UNITED STATES PATENT AND TRADEMARK OFFICE

APPLICATION NO.	FILING DATE	FIRST NAMED INVENTOR	ATTORNEY DOCKET NO.	CONFIRMATION NO.
10/796,471	03/09/2004	Leilei Zhang	X-1574 US	2282
24309	7590	03/06/2007		
XILINX, INC ATTN: LEGAL DEPARTMENT 2100 LOGIC DR SAN JOSE, CA 95124			EXAMINER DIAZ, JOSE R	
			ART UNIT	PAPER NUMBER
			2815	
SHORTENED STATUTORY PERIOD OF RESPONSE		MAIL DATE	DELIVERY MODE	
3 MONTHS		03/06/2007	PAPER

Office Action Summary	Application No.	Applicant(s)	
	10/796,471	ZHANG, LEILEI	
	Examiner	Art Unit	
	José R. Díaz	2815

DETAILED ACTION

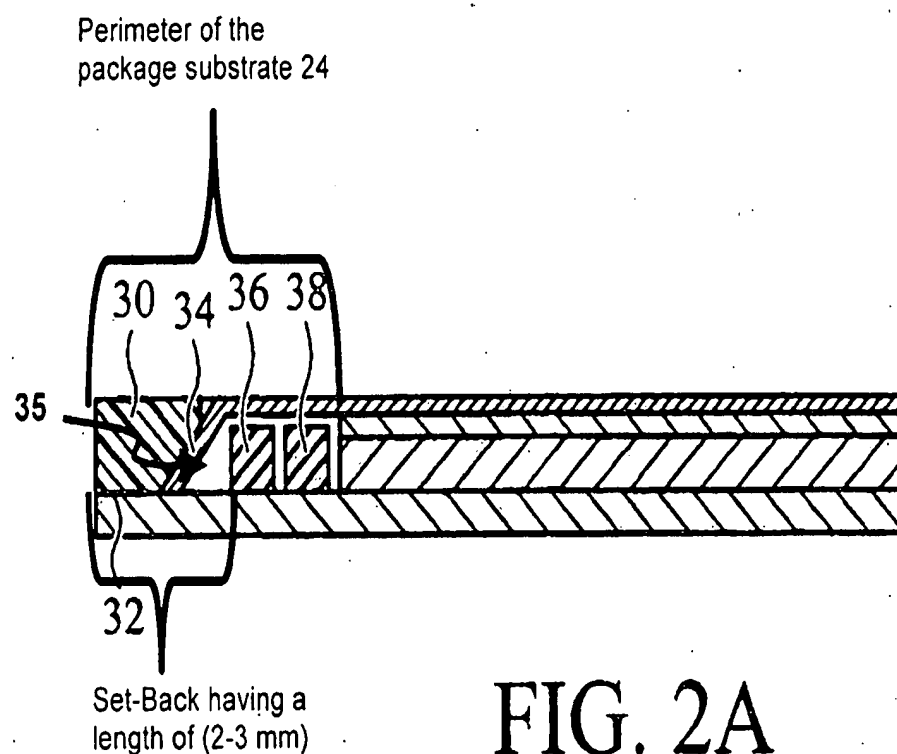
2. The amendment filed February 2, 2007 is objected to under 35 U.S.C. 132(a) because it introduces new matter into the disclosure. 35 U.S.C. 132(a) states that no amendment shall introduce new matter into the disclosure of the invention. The added material which is not supported by the original disclosure is as follows: the original disclosure does not support the subject matter now added to paragraph 0030 since the original disclosure fails to suggest, explicitly or implicitly, that no molding compound is introduced in the space 35, as now proposed by applicant. To the contrary, the original disclosure suggests that molding compound is added in the argued space. For example, paragraph 0030 (of the original specification) discloses that the molding compound is formed on "about 2 mm to about 3 mm of the perimeter of the package substrate 24" [emphasis added]. In addition, paragraph 0030 discloses that "[T]he set-back from the edge of the package substrate 24 to the chip capacitors 36, 38 is typically about 2-3

mm," which is the same length or region disclosed for the molding compound. Please note that this set back region includes the argued space 35 (see fig. 2A, attached below). Thus, the molding compound is also present in the space 35.

In addition, the proposed figures are objected since the cross sectional view as shown in figure 2A does not correspond to the cross section taken along the proposed line A-A in figure 2B. For instance, figure 2A shows a sloped wall (34) completely covered (from top to bottom) with molding compound (30). However, line A-A in figure 2B shows a partially covered sloped wall (34) (see the top portion of the sloped wall that is not covered with molding compound 30). Therefore, the figures remain objected by the examiner.

3. The drawings are objected to because the disclosure fails to describe the "space" or "gap" that is enclosed by package lid 10, substrate 24 and semiconductor IC 26; and that surrounds chips 36 and/or 38 [see figures 2A and 2C]. Corrected drawing sheets in compliance with 37 CFR 1.121(d) are required in reply to the Office action to avoid abandonment of the application. Any amended replacement drawing sheet should include all of the figures appearing on the immediate prior version of the sheet, even if only one figure is being amended. The figure or figure number of an amended drawing should not be labeled as "amended." If a drawing figure is to be canceled, the appropriate figure must be removed from the replacement sheet, and where necessary, the remaining figures must be renumbered and appropriate changes made to the brief description of the several views of the drawings for consistency. Additional replacement sheets may be necessary to show the renumbering of the remaining figures. Each drawing sheet submitted after the filing date of an application must be labeled in the top margin as either "Replacement Sheet" or "New Sheet" pursuant to 37 CFR 1.121(d). If the changes are not accepted by the examiner, the applicant will be notified and informed of any required corrective action in the next Office action. The objection to the drawings will not be held in abeyance.

Applicant is required to cancel the new matter in the reply to this Office Action.

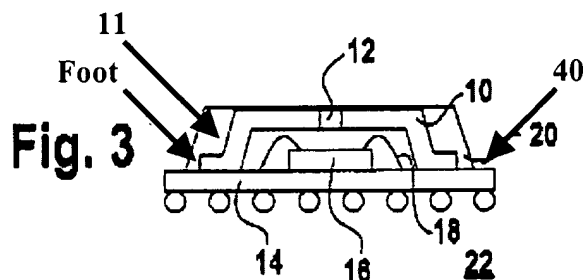
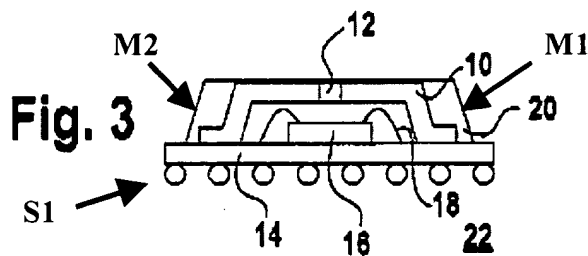
Regarding claims 1 and 31, Fishley et al. teaches a package lid for attaching to a package substrate of a packaged semiconductor comprising a sloped wall (11) configured to provide an exposed perimeter portion (40) of the package substrate (14) [see fig. 3, attached below]. With regards to the limitation that the sloped wall is used or configured to provide an exposed perimeter portion when the package lid is disposed on the package substrate, the court has held that a recitation of the intended use of the claimed invention must result in a structural difference between the claimed invention and the prior art in order to patentably distinguish the claimed invention from the prior art. See *In re Pearson* 181 USPQ 641 (CCPA 1974) and *In re Swinehart* 169 USPQ 226 (CCPA 1971). In the instance case, Fishley et al. teaches a sloped wall (11) configured to provide an exposed perimeter portion (40) of the package substrate (14) when the package lid (10) is disposed on the package substrate (14) to allow application of a molding compound (20) on the exposed perimeter portion (40) of the package substrate (14), the molding compound (20) contacting the sloped wall (11) to secure the package lid (10) to the package substrate (14) of the packaged semiconductor (22) [see fig. 3,

Regarding claim 3, Fishley et al. teaches a foot ("foot") around at least a portion of the perimeter of the sloped wall (11), configured to contact the package substrate (14) when the package lid (10) is placed on the package substrate (14) [see figs. 1 and 3].

Regarding claim 4, Fishley et al. teaches the package lid (10) is a stamped package lid [please note that the lid was stamped or cut out to form opening 12. See fig. 3].

Regarding claim 10, Fishley et al. further teaches a vent (12) provided on the top side of the package lid (10) [see fig. 3].

Regarding claim 19, Fishley et al. further teaches that the package lid (10) is disposed on the package substrate (14) to provide the exposed perimeter portion and further comprising: first molding compound (M1) applied to a first portion of the exposed perimeter portion (portion of substrate 14 covered with first molding compound M1) and contacting the sloped sidewall (11) [see fig. 3, below], and second molding compound (M2) applied to a second portion of the exposed perimeter portion (portion of substrate 14 covered with first molding compound M2) and contacting the sloped sidewall (11); wherein the first portion of the exposed perimeter portion is opposite the second portion of the exposed perimeter portion [see fig. 3, below].

Regarding claim 21, Fishley et al. teaches the package substrate includes a solder ball-grid array (S1) for connecting the packaged semiconductor to a printed circuit assembly [see fig. 3, above].

Regarding claims 18 and 20, Fishley et al. teaches the exposed perimeter portion (40) of the package substrate (14) in figure 3. However, Fishley et al. fails to teach a package substrate comprising polymer material or an organic resin.

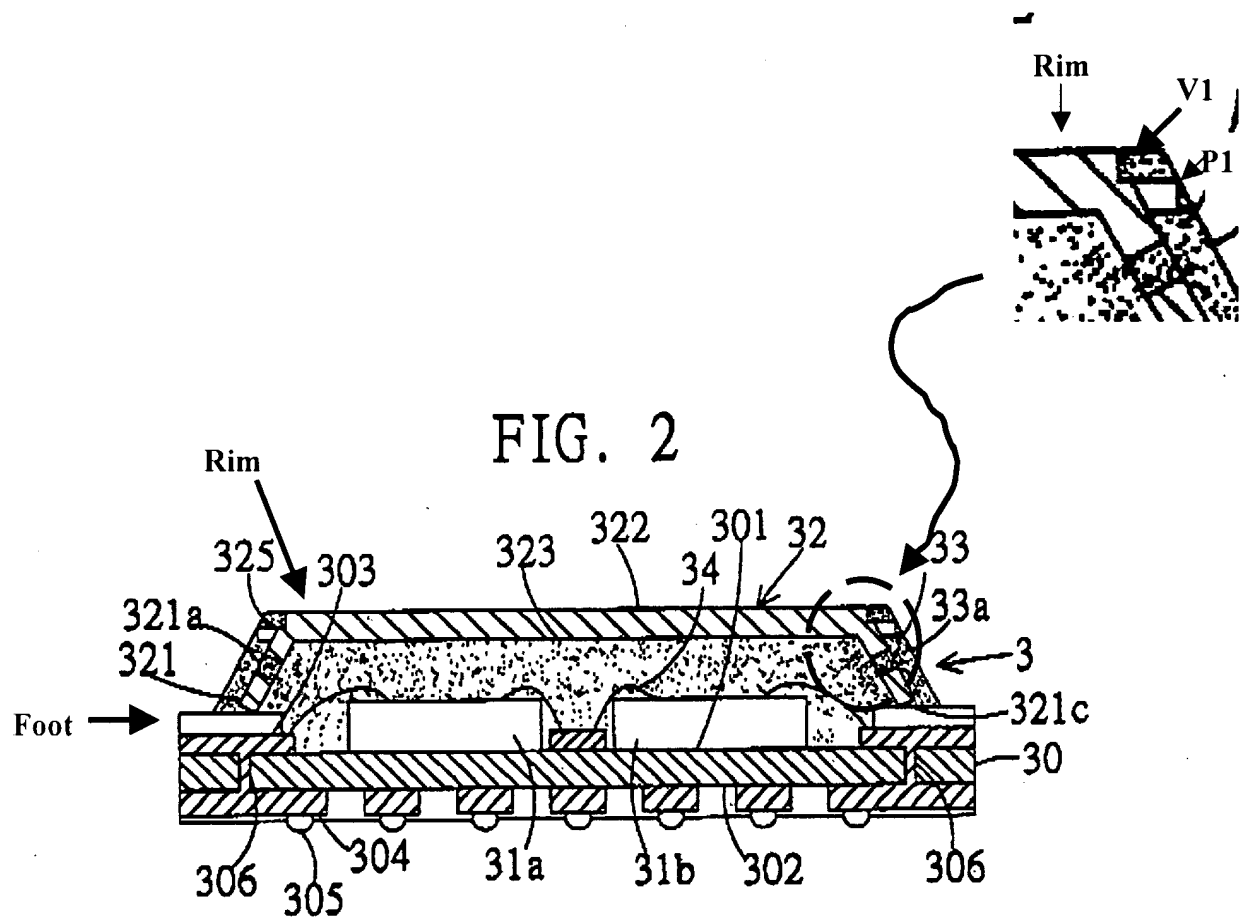
Regarding claim 1, Tang et al. teaches a package lid for attaching to a package substrate of a packaged semiconductor comprising a sloped wall (321) [see figures 1 and 2] With regards to the limitation that the sloped wall is used or configured to provide an exposed perimeter portion when the package lid is disposed on the package substrate, the court has held that a recitation of the intended use of the claimed invention must result in a structural difference between the claimed invention and the prior art in order to patentably distinguish the claimed invention from the prior art. See *In re Pearson* 181 USPQ 641 (CCPA 1974) and *In re Swinehart* 169 USPQ 226 (CCPA 1971). In the instance case, Tang et al. teaches a sloped wall (321) configured to provide an exposed perimeter portion (area not covered with molding 33) of the package substrate (30) [see figs. 1 and 2]. Thus, Tang et al. anticipates the claimed invention since the prior art structure is capable of performing the claimed intended use.

Regarding claim 9, Tang et al. teaches a vent (326, 321a) allowing gases to escape during assembly of the packaged semiconductor to a printed circuit assemble [see figs. 1-2].

Regarding claim 12, Tang et al. teaches a vertical wall (V1) around a top (322) of the package lid (32) [see fig. 2, attached above].

Regarding claim 13, Tang et al. teaches fiducial marks (consider protrusion P1 or 325) formed in the rim (V1) [see fig. 2, attached above].

Regarding claim 19, Tang et al. teaches a first molding compound (consider the molding compound 33 formed on the sloped wall (321) located on the left side of the structure as shown in figure 2). and a second molding compound (consider the molding compound 33 formed on the sloped wall (321) located on the right side of the structure as shown in figure 2).

Regarding claim 21, Tang et al. teaches a solder ball grid array (305) [see fig. 2].

Regarding claim 11, Fishley et al. fails to teach a gap in the sloped wall. However, Tang et al. teaches the claimed limitation in figure 2. For instance, Figure 2 shows a gap (321a) in the sloped wall (321) of the package lid (32).

Regarding claim 2, Fishley et al. teach a sloped wall (11) which appears to be inclined at an angle of less than 90° [see fig. 3]. However, Fishley et al. fails to explicitly teach an angle of between 30° and 60°. Tang et al. appears to show a sloped wall (321) of about 45° [see fig. 2]. Thus, it would have been obvious to one of ordinary skill in the art to include a sloped wall having an angle of between 30° and 60°, since it has been held that where the general conditions of a claim are disclosed in the prior art, discovering the optimum or working ranges involves only routine skill in the art. *In re Huang*, 40 USPQ2d 1685,1688(Fed. Cir. 1996) citing *In re Aller*, 105 USPQ 233., 235 (CCPA 1955).
